**AMENDMENTS TO THE DRAWINGS**

**REMARKS**

FIG.13

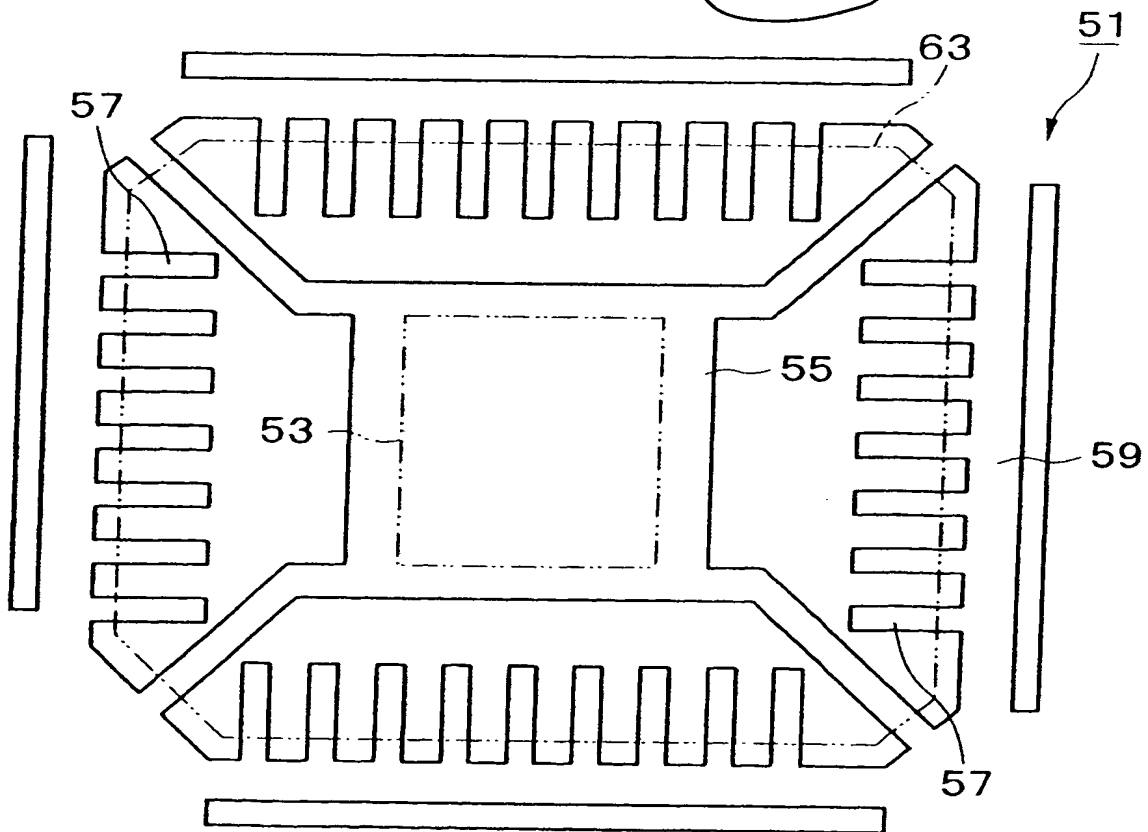
In paragraph 4 of the Office Action, the drawings have been objected to. Specifically, Figures 13-15 have been objected to as not being labeled as prior art. Applicant submits herewith redline and replacement sheets containing amendments to these figures to label them as prior art. The drawings have further been objected to as reference character 21 was incorrectly used to designate the through hole. Figure 1 has been amended to remove the incorrect designation of the through hole as reference character 21. This reference character is properly used in at least Figure 3a to indicate the circuit board. Applicants have submitted herewith redlined and replacement sheets of these drawings in order to correct these errors. No new matter is entered by these corrections. Withdrawal of the objections to the drawings is therefore respectfully requested.

PRIOR ART
